Model: TM80/TM100

Product Bulletin # TM-033 Rev 1

Tong Valve Bracket Improvement

Figure 3: New support bracket design as shown

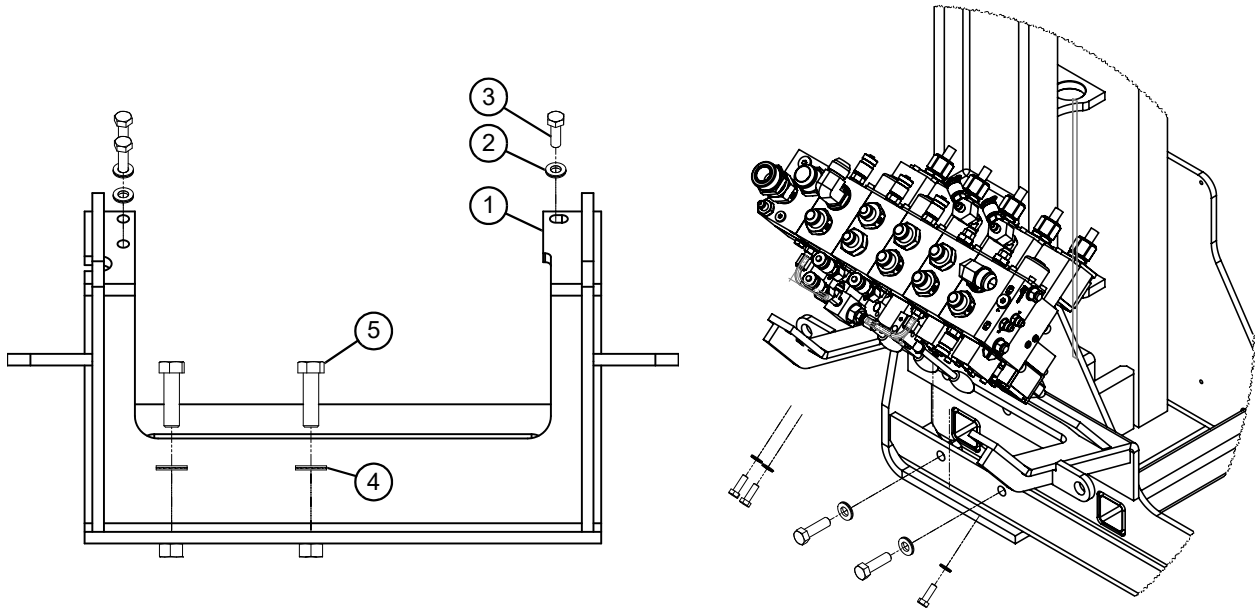
On some Canrig Torq-Matic™ Wrenches, the end of the mounting bracket where the tong valve bolts may break off and/or the mounting hardware for the tong valve assembly may break due to vibration resulting in damage to the valve bank. A new mounting bracket has been designed to support the valve bank from below, taking the strain off the mounting hardware. This new bracket will significantly reduce failures and minimize damage to the valve bank if the mounting hardware fails.

2. Remove hoses from the valve bank, if necessary. Remove the valve bank from existing support brackets and then remove existing support brackets from the frame.
3. Install the new bracket to the frame using items 4 and 5, as shown in Figure 3 on page 3.
4. Install the valve bank to the new bracket using items 2 and 3, as shown in Figure 3 on page 3.
5. Reconnect hoses to the valve bank, if removed on step 2.
6. Remove LOTO.

If you decide to install the revised bracket mount on Wrench models TM80/100, order the kit (Canrig P/N: AY25947) including the new bracket and required mounting hardware.
